**Economic Commission for Europe****Inland Transport Committee****World Forum for Harmonization of Vehicle Regulations****Working Party on General Safety Provisions****105<sup>th</sup> session**

**Regulation No. 107 (M<sub>2</sub> and M<sub>3</sub> vehicles) –****Proposals for further amendments****Proposal for further amendments to Regulation No. 107 (M<sub>2</sub> and M<sub>3</sub> vehicles)****Submitted by the expert from Belgium\***

The text reproduced below was prepared by the expert from Belgium to align the additional safety prescriptions for trolleybuses with the corresponding electrical standards. It supersedes informal document GRSG-104-13. The modifications to the current text of the regulation are marked in bold for new and strikethrough for deleted characters.

- (a) **Vehicle broadband reference limits**  
**Antenna vehicle - overhead contact line separation 10 m**

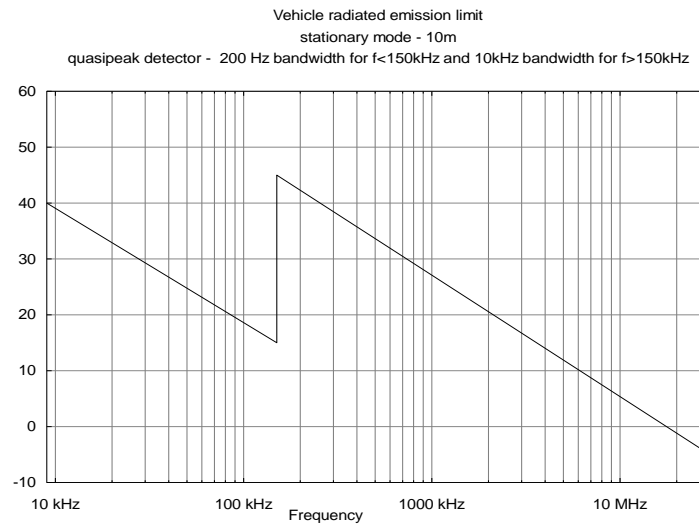
**"3.11.3. Reference limits for emission of the vehicle for type approval are as specified in the following diagrams:**

**Limit H (dBμA/m) at frequency F (MHz):**

**0.009 – 0.150 MHz**

**0.150 – 30 MHz**

$$H = 40 - 20.46 \cdot \log ( F / 0.009 )$$

$$H = 45 - 21.73 \cdot \log ( F / 0.15 )$$

**(b) Vehicle broadband reference limits**  
**Antenna vehicle - overhead contact line separation 10 m**

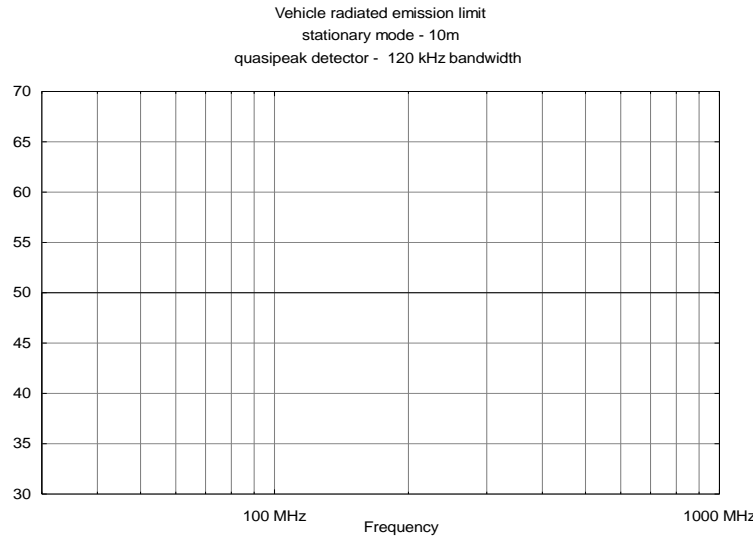
**Limit E (dBμV/m) at frequency F (MHz):**

**30 – 1000 MHz**

**E = 50**

**(c) Vehicle broadband reference limits**  
**Antenna vehicle - overhead contact line separation 10 m**

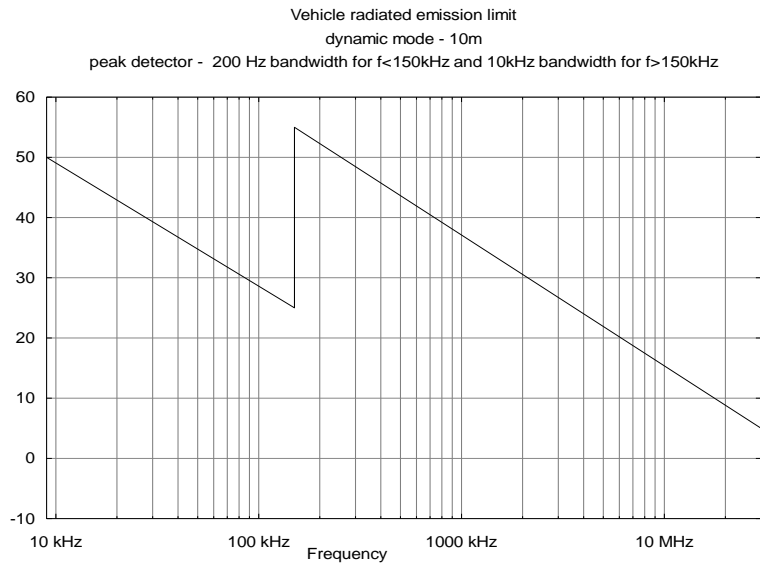
**Limit H (dBμA/m) at frequency F (MHz):**

**0.009 – 0.150 MHz**

**0.150 – 30 MHz**

**H = 50 – 20.46 · log ( F / 0.009 )**

**H = 55 – 21.73 · log ( F / 0.15 )**

(d) **Vehicle broadband reference limits**  
**Antenna vehicle - overhead contact line separation 10 m**

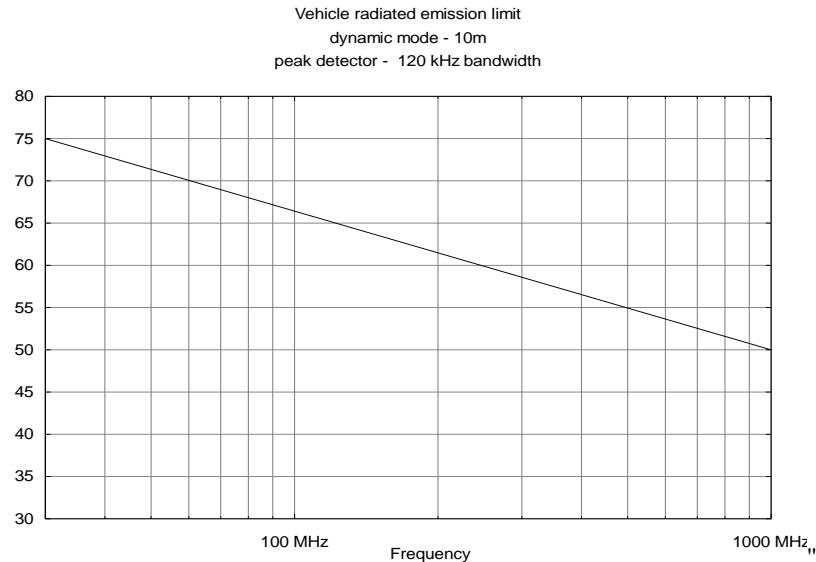
**Limit E (dB $\mu$ V/m) at frequency F (MHz)**

**30 – 1000 MHz**

$$E = 75 - 16.42 \cdot \log ( F / 30 )$$
